• A D D E N D U M # 4 •

TO ALL PLAN HOLDERS	DATE	JOB NO.:
	July 16, 2015	2302-023
	ATTN	Plan Holders
	RE	City of Newport Newport Ferry Slip Road Improvements

**City of Newport
Newport Ferry Slip Road Improvements
Project No. 2302-023**

CITY OF NEWPORT
LINCOLN COUNTY, OREGON
SE FERRY SLIP ROAD
ROADWAY IMPROVEMENTS
GRADING PLAN & PROFILE -
STA 4+50 TO STA 9+00
C202
July 2015

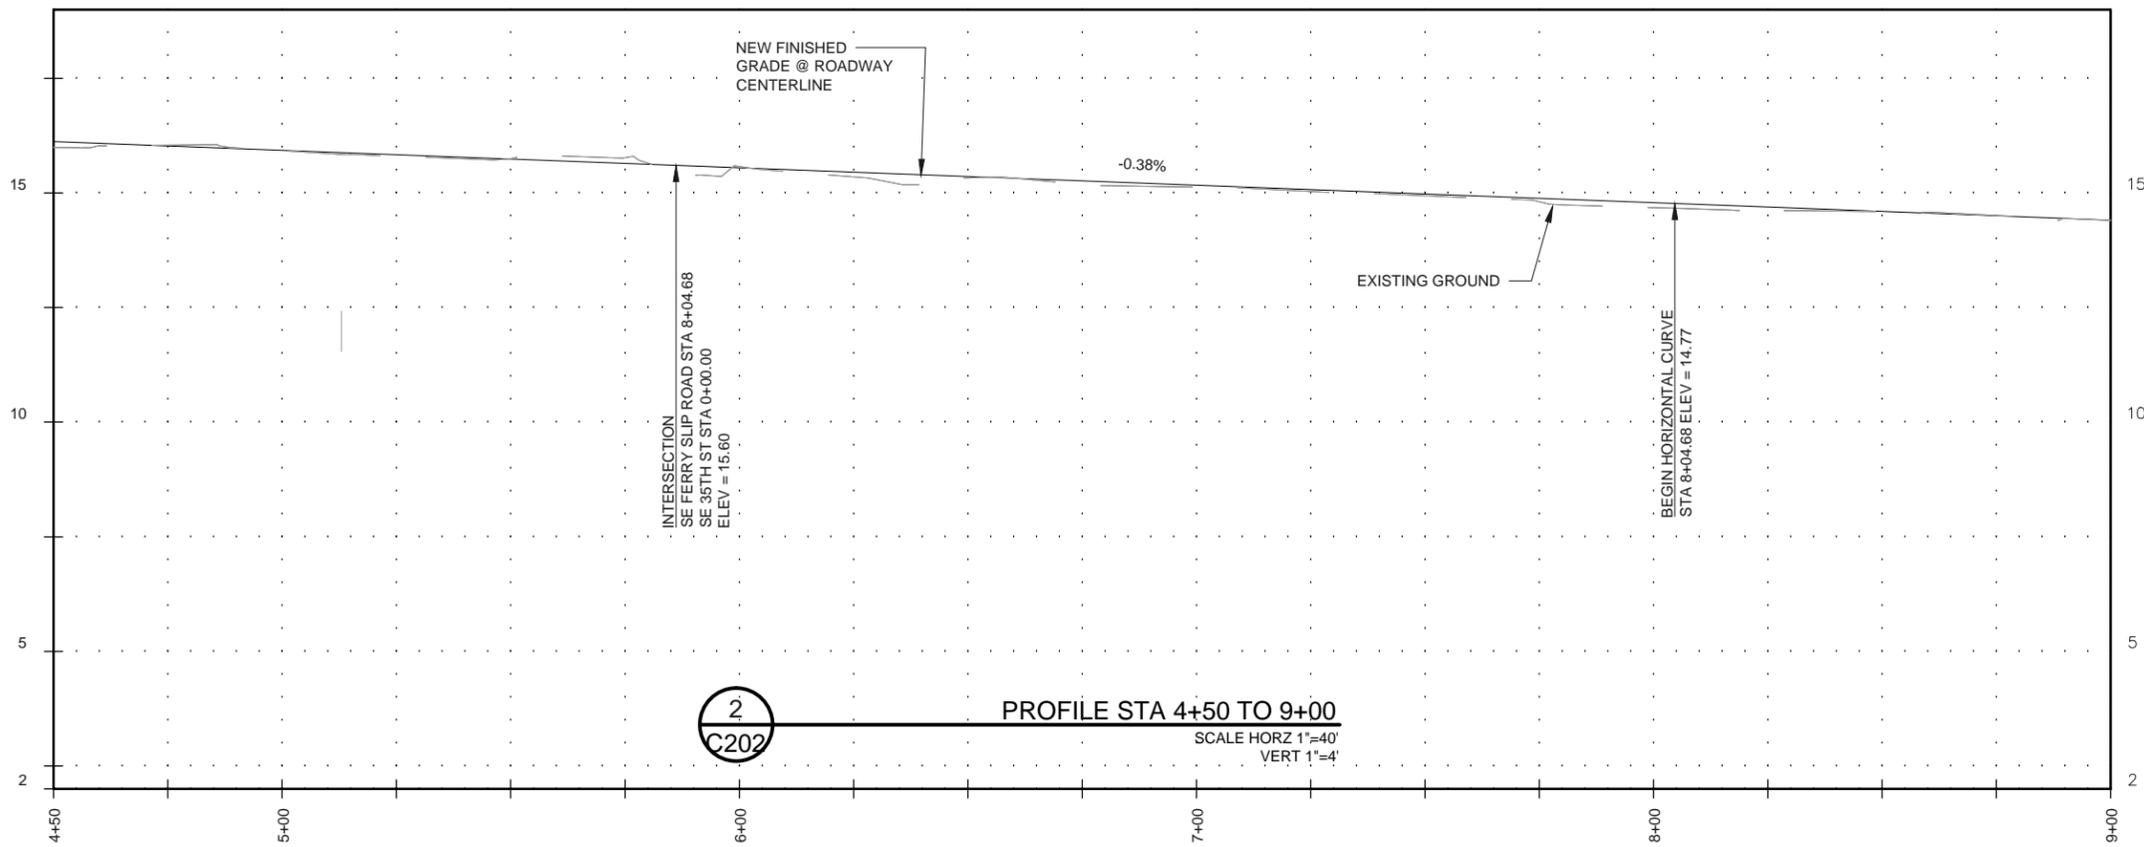
1. **D4** – 2" Agg Base $\frac{3}{4}$ "-0 Leveling Course under sidewalk.
2. **C202** – 35th street handicap ramps
3. **C203** – 32nd street handicap ramp
4. **C204** – Remove: New 4" Thick $\frac{3}{4}$ "-0 Agg Base
5. **C205** – New 2" Gravel Surface
6. **C401** – Striping plan
